DRAFT MA ON SHAN OUTLINE ZONING PLAN NO. S/MOS/23 CONSIDERATION OF REPRESENTATIONS NO. R1 TO R5699 AND COMMENTS NO. C1 TO C1587

- 1.1 On 16.10.2020, the draft Ma On Shan Outline Zoning Plan No. S/MOS/23 (the draft OZP) (**Annex I**) was exhibited for public inspection under section 5 of the Town Planning Ordinance (the Ordinance). The Schedule of Amendments setting out the amendments is at **Annex II** and the locations of the amendment items are shown on **Plans H-1a to H-1c**.
- 1.2 During the two-month statutory exhibition period, a total of 5,699 valid representations were received. On 29.1.2021, the representations were published for 3 weeks for public comments. Upon expiry of the three-week exhibition period, a total of 1,587 valid comments on the representations were received¹.
- 1.3 On 23.4.2021, the Town Planning Board (the Board) agreed to consider all the representations and comments collectively in one group.

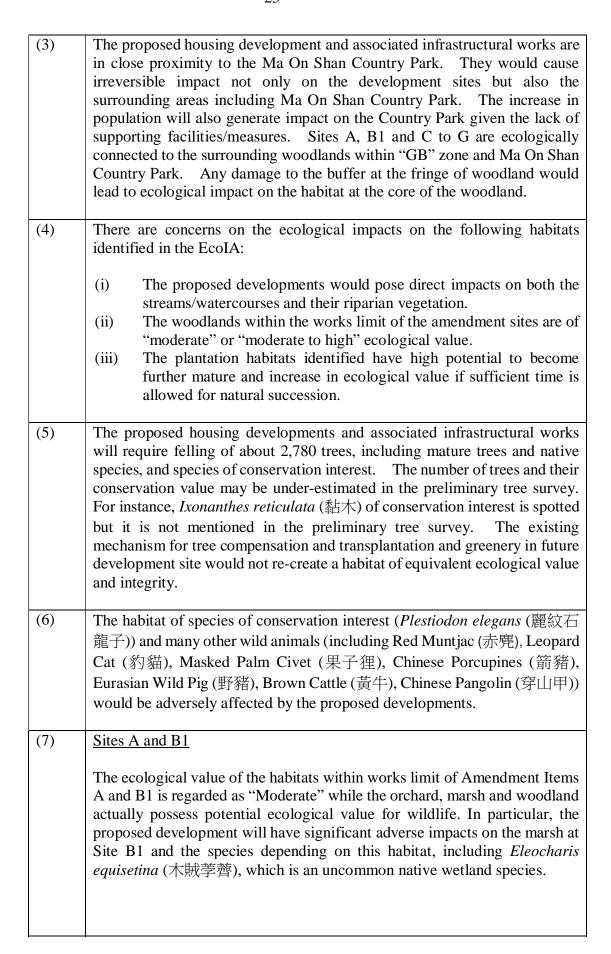
(g) In response to (7):

(i) According to the PTTIA, with the proposed mitigation measure of converting the existing Chak Cheung Street/Science Park Road roundabout to a signalized-controlled junction (**Annex Xb**), the concerned junction would have sufficient capacity to cater for the traffic generated by the proposed housing developments, i.e. no significant traffic impact is envisaged for the vehicles travelling from

T6 Bridge (northbound) to Fo Tan. Besides, the Government will implement improvement measure to widen the section of Tate's Cairn Highway (southbound) near A Kung Kok from three lanes to four lanes (**Annex Xa**). The v/c ratio of the concerned road link will be reduced to 0.88. Traffic impact at the merging point of Ma On Shan Road and T6 Bridge can thus be addressed.

- (ii) There are planned public transport termini at Shap Sz Heung and Nai Chung (to be re-provided under the Sai Sha Road widening project). As advised by CEDD, the bus layby along the proposed access road for Sites A and B1 has can also accommodate three buses serving as terminal facilities.

- (iii) HyD commenced the "Strategic Study on Railways beyond 2030" in the end of 2020. HyD will consider the "Hong Kong 2030+: Towards a Planning Vision and Strategy Transcending 2030" (Hong Kong 2030+) to examine the layout of the proposed railway network in Hong Kong, as well as to conduct preliminary technical assessments on proposed railway alignment and associated facilities, in order to ensure that the planning of large-scale transport infrastructure will meet the needs for the long-term land use developments of Hong Kong.

- (iv) As advised by RDO of HyD, according to the current mechanism, planning and implementation of the station modification works are under MTR Corporation Limited's (MTRCL) own strategy and fund. Any suggestions of additional exit in Tai Shui Hang Station and Heng On Station by the public could be conveyed to MTRCL direct.
